**STATE OF CONNECTICUT
CONNECTICUT SITING COUNCIL**

APPLICATION OF SBA TOWERS II LLC
FOR A CERTIFICATE OF ENVIRONMENTAL
COMPATIBILITY AND PUBLIC NEED FOR
THE CONSTRUCTION, MAINTENANCE AND
OPERATION OF A TELECOMMUNICATIONS
FACILITY AT 44 GAVITT ROAD,
BARKHAMSTED, CONNECTICUT

DOCKET NO. 387

**APPLICANT'S RESPONSES TO FIRST SET OF INTERROGATORIES FROM
CONNECTICUT SITING COUNCIL**

2006 Aerial Photograph
 Proposed SBA Towers II LLC
 Wireless Telecommunications Facility
 Barkhamsted
 44 Gavitt Road
 Barkhamsted, Connecticut

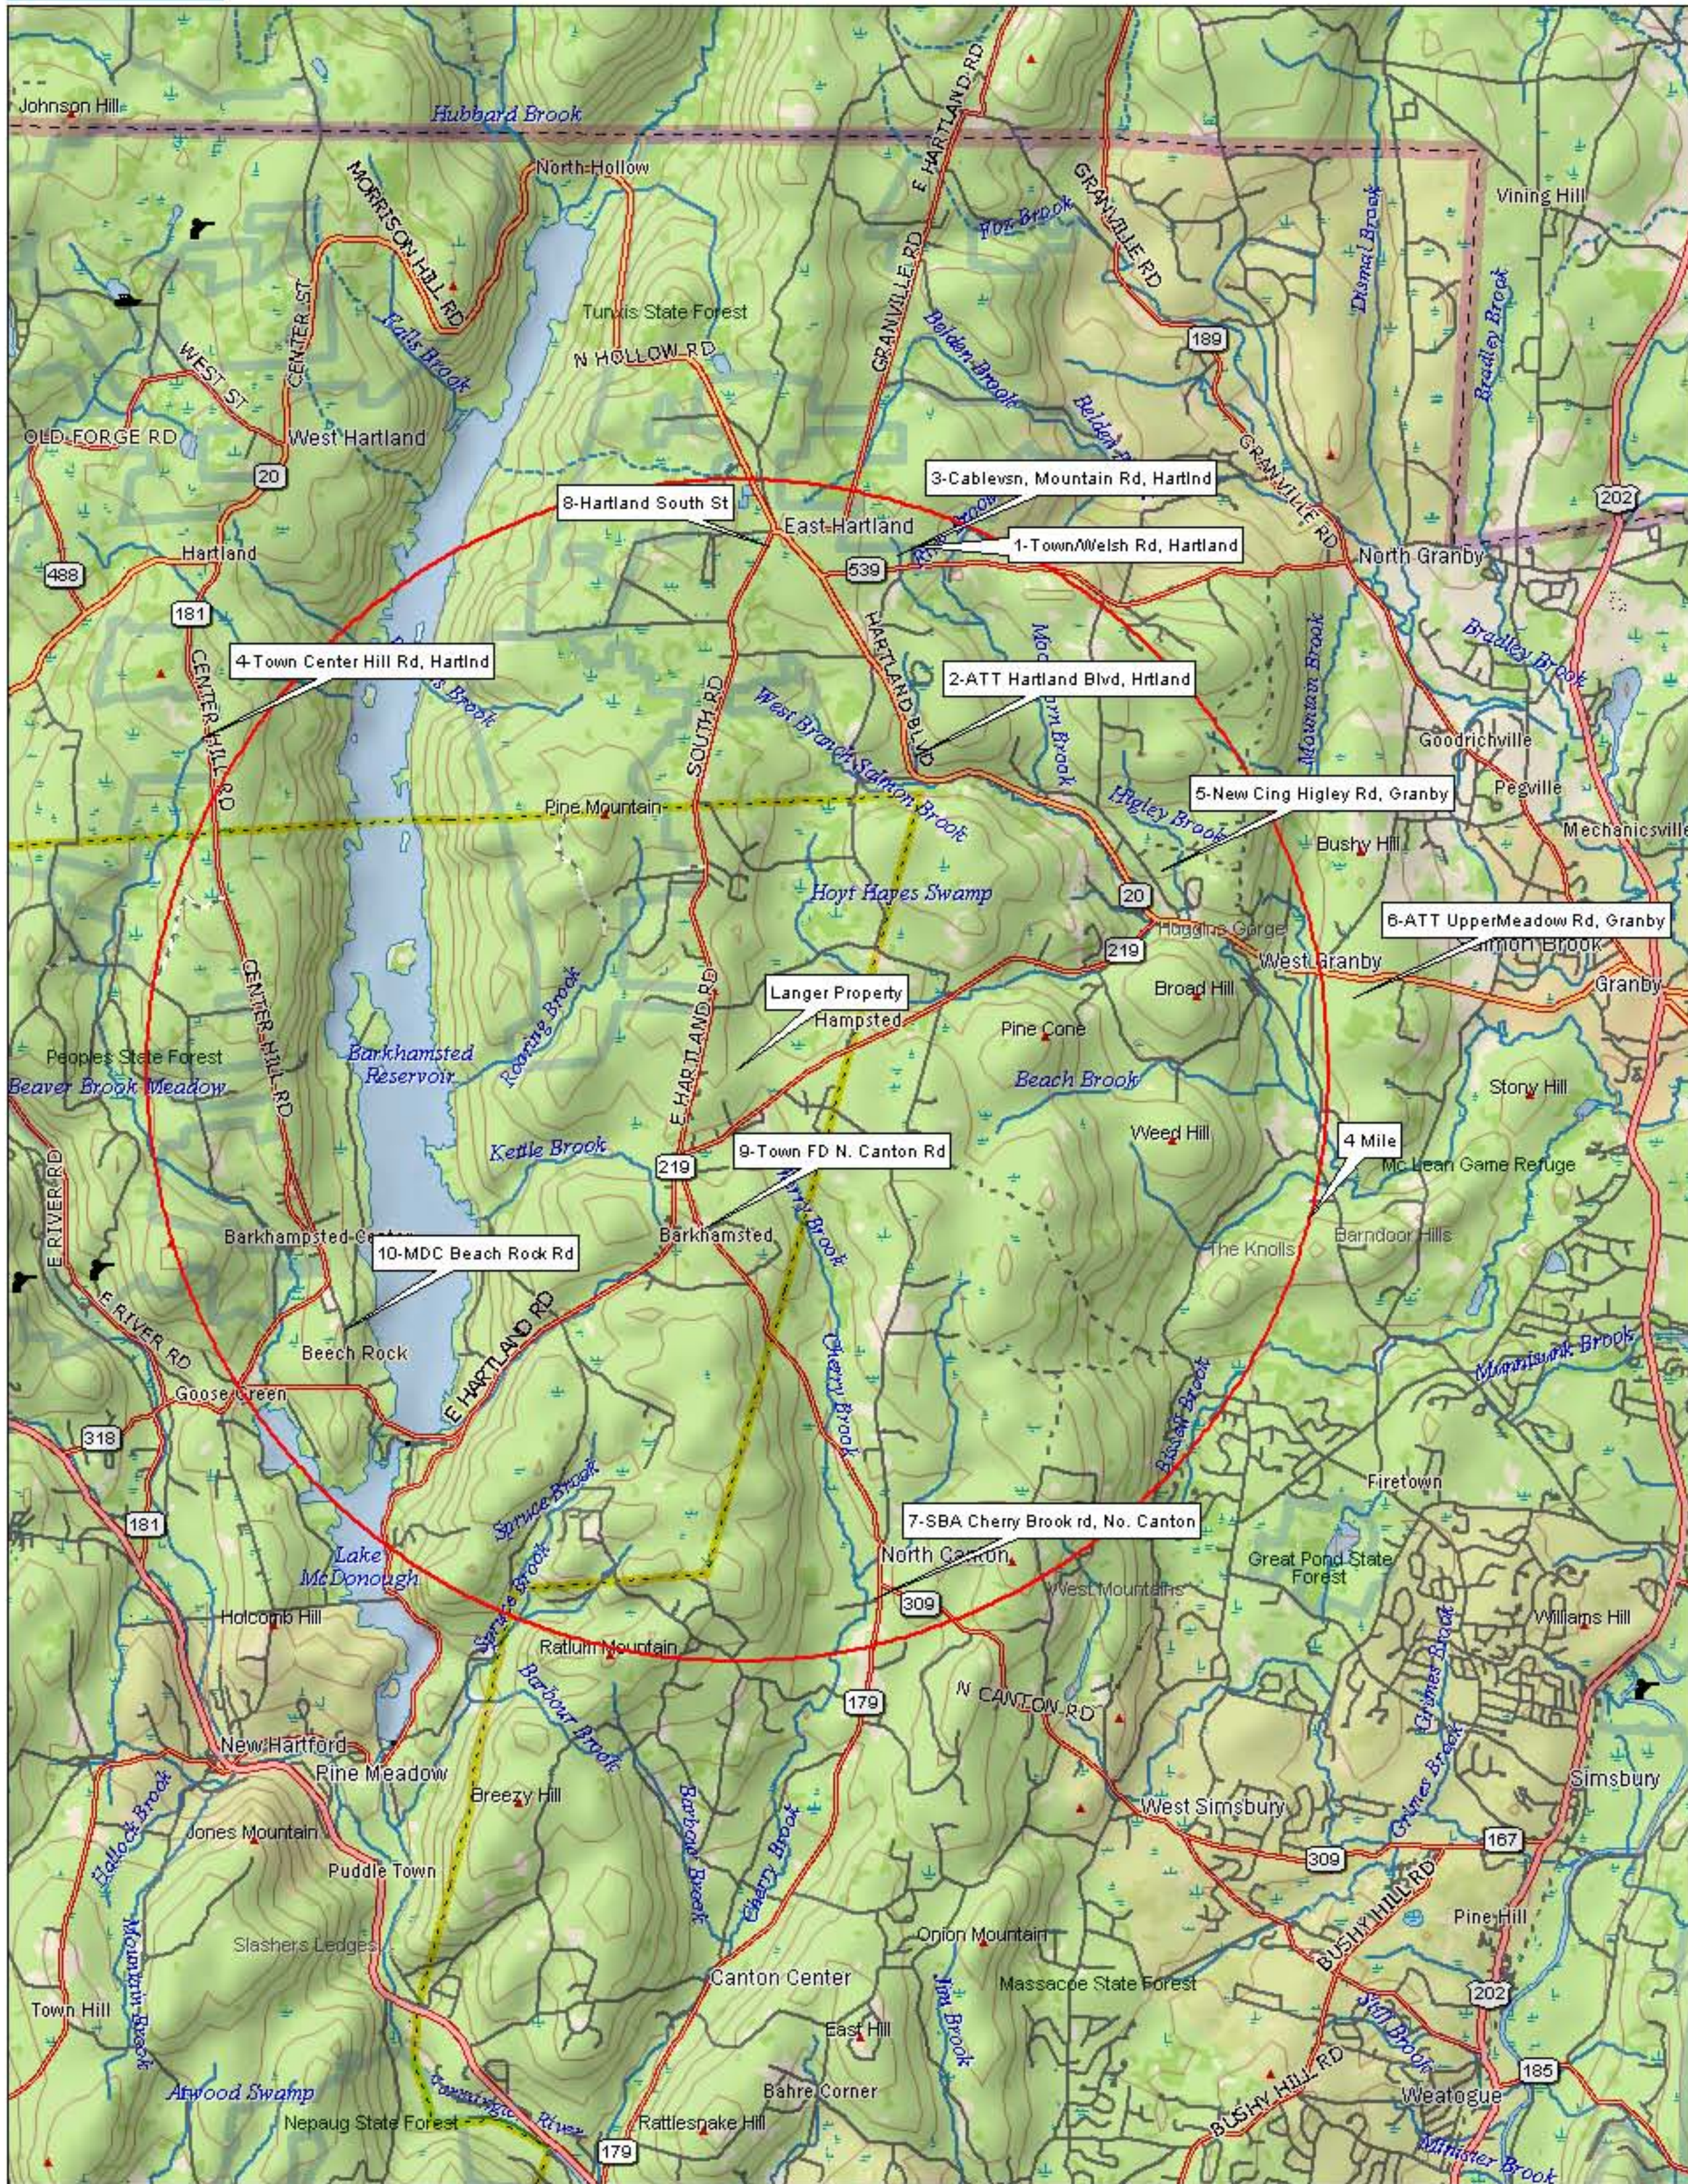
Q9. Supply a color aerial photograph of the vicinity of the proposed site.

A9. See aerial photograph attached hereto as Exhibit 2.
